Ahsan Composite Ltd. (Extension)

30 November 2023

1. Building Information

Observation-1: Steel columns are stressed above normal design limit. [Building-07 (Production Building)]

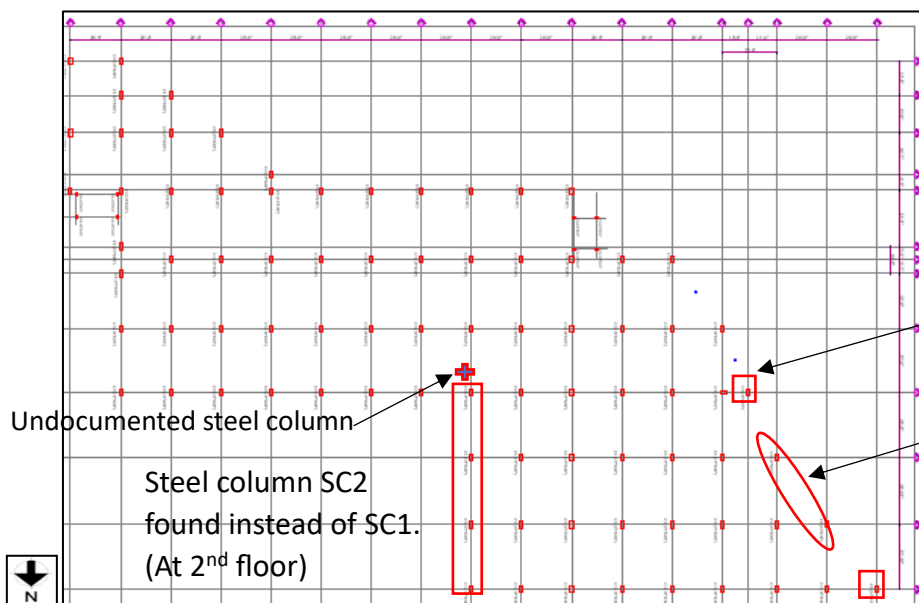
Description: Cursory calculation indicates that the marked area appears to be stressed above normal design limits based on prepared live load plan (3 kPa for typical and 6 kPa for storage) and minimum steel plate strength (250 MPa). Also, foundation details and geotechnical investigation report were not found onsite. The building engineer is required to carry out Detail Engineering Assessment (DEA) to review the design, loads and column stress based on in-situ material strength and floor live loads.

Observation-2: Incomplete drawing. [Building-07 (Production Building)]

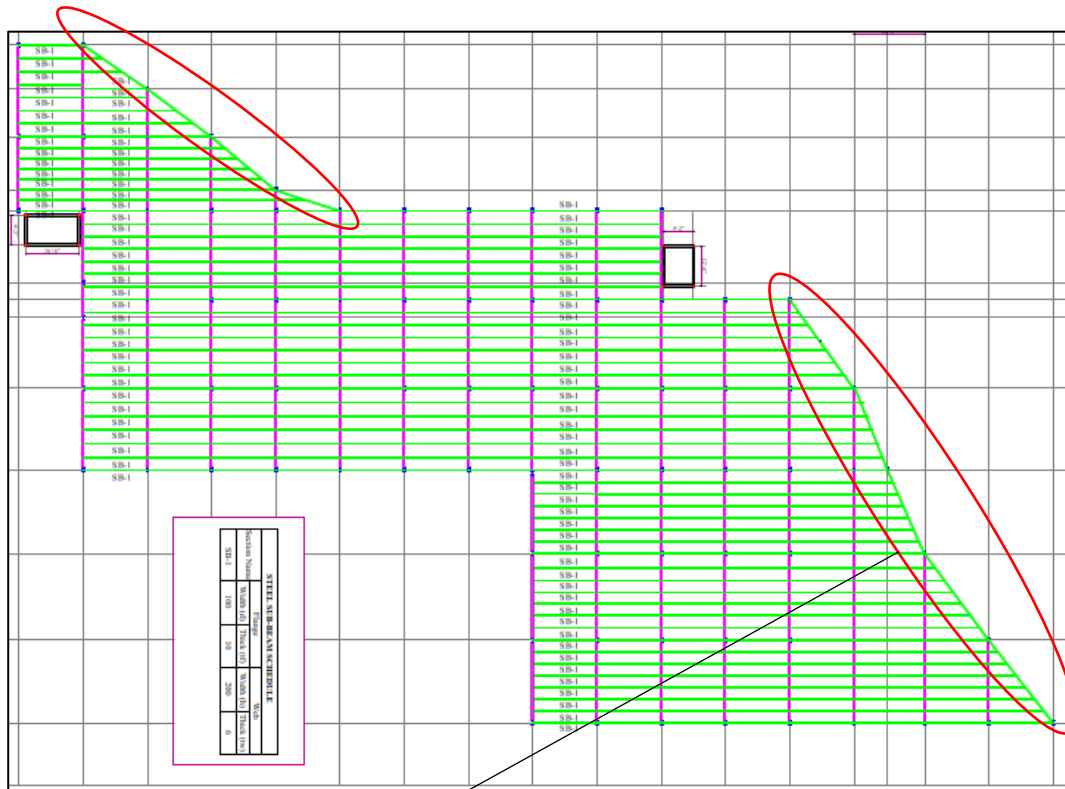
Steel column SC3 found instead of (200x400) mm instead of (200x260) mm. (At 2nd floor)

Steel column SC1 found instead of SC3. (At 2nd floor)

Steel column SC1 found instead of SC3. (At 2nd floor)
(280x550) mm

Steel column SC3 found
(200x400) mm instead of
(200x260) mm. (At 2nd floor)

Steel column SC2 found instead of SC1. (At 2nd floor)

Undocumented steel column

SC3 found 250x360 instead of 200x260. (At ground floor)

Marked beam details not shown in drawing (180x400) mm

Sub beam size was found (125x350) mm instead of (100x200) mm

Frame section missing in the prepared drawing

Undocumented pipe column at ground floor

- No foundation information was provided in the drawing.
- Mismatch was found in the column layout and column schedule.
- Mismatch was found in beam layout and beam schedule.
- Mismatch found in connection details.

The building engineer is required to survey the full structure and prepare complete as-built drawing.

Observation-7: Settlement on the ground. [Building 07 (Production Building)]

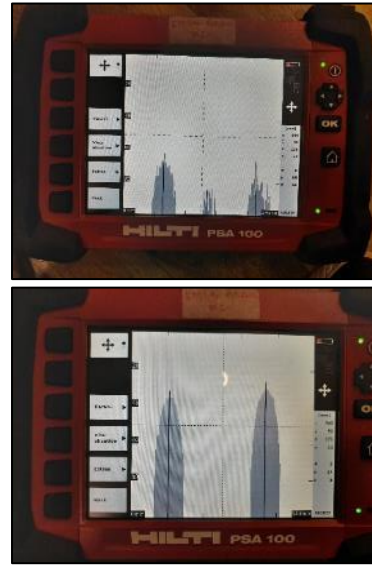
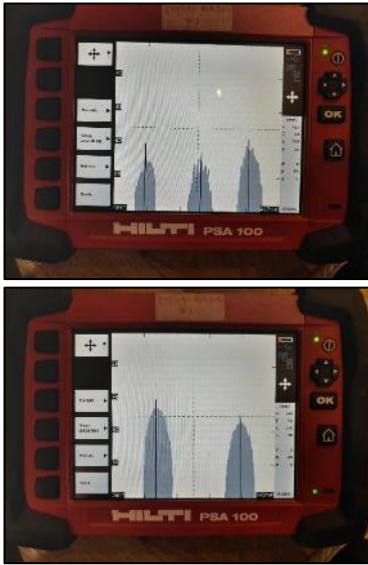
Description: During inspection, signs of settlement were observed on the ground beside the heavily loaded stenter machine. The building engineer is required to investigate the actual reason of settlement and take necessary remedial measure as per engineer suggestion.

Observation-9: Mismatch in as-built drawing. [Building 11 (Dyes Chemical Store)]

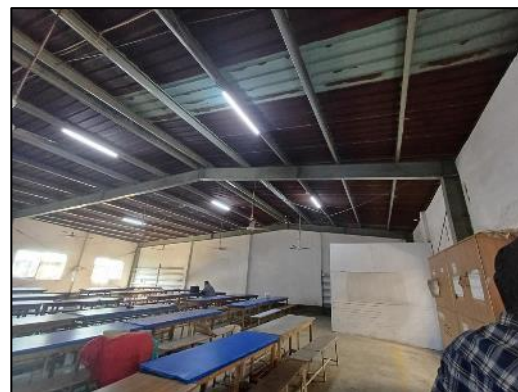
C4 column: 6 rebar found instead of 10

C1 column: 6 rebar found instead of 8 nos.

- No foundation information was provided in the drawing.
- A mismatch was found in the column schedule.

The building engineer is required to survey the full structure and prepare complete as built drawing.
